# UNITED STATES PATENT AND TRADEMARK OFFICE

APPLICATION NO.	FILING DATE	FIRST NAMED INVENTOR	ATTORNEY DOCKET NO.	CONFIRMATION NO.
10/650,201	08/28/2003	Michael Ebenhoch	ZAHFRI P529US	7148

<b>Office Action Summary</b>	<b>Application No.</b> 10/650,201	<b>Applicant(s)</b> EBENHOCH ET AL.	
	<b>Examiner</b> Saúl J. Rodríguez	<b>Art Unit</b> 3681

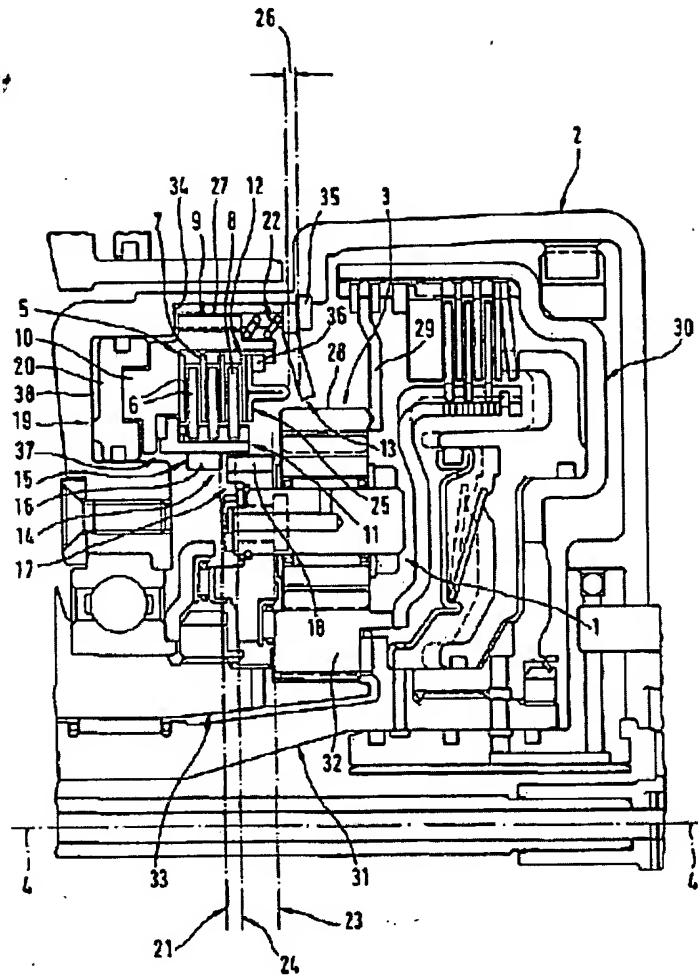
DE discloses a transmission having a coupling device (15, 18), an actuator (20) or piston control unit, and a second spring device (22). DE, however, does not show a friction member.

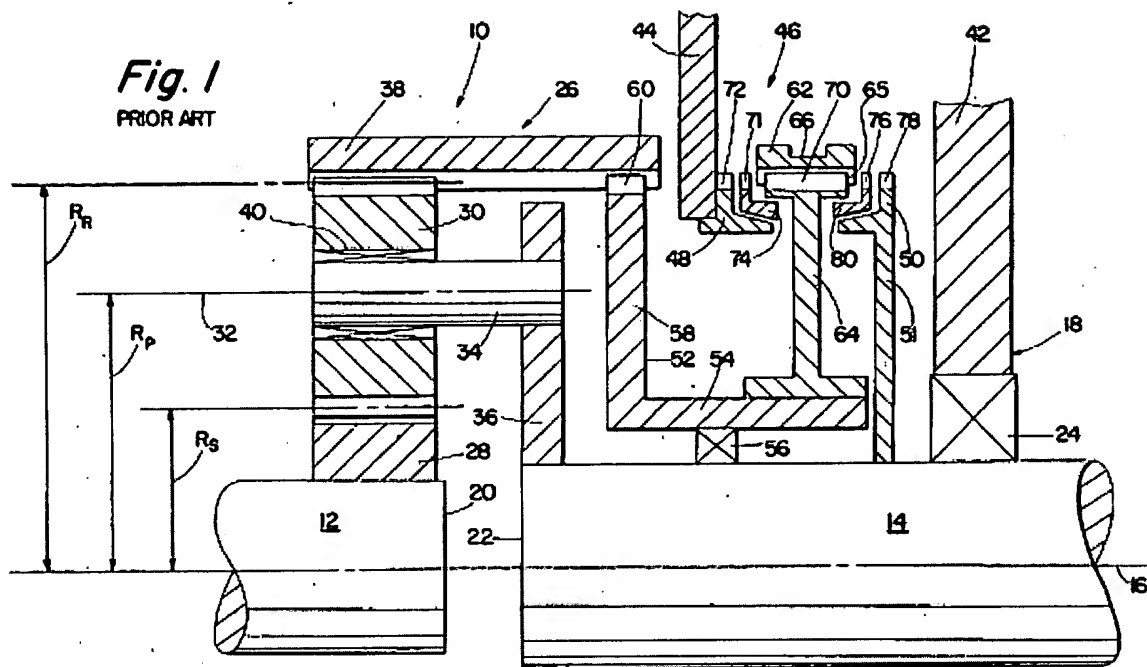
It is very conventional, however, to provide a frictional device between positively coupling elements for synchronization purposes. For example, Harper discloses a transmission (Fig. 1) comprising rotating transmission components (12, 14), non-rotating transmission components (44), coupling device (46), a frictional element (74) and a positive locking device (62, 72).

Then, it would have been obvious to a person of ordinary skill in the art at the time the invention was made to provide a synchronizing frictional element in the coupling of DE in view of Harper to reduce the NVH of the transmission device.
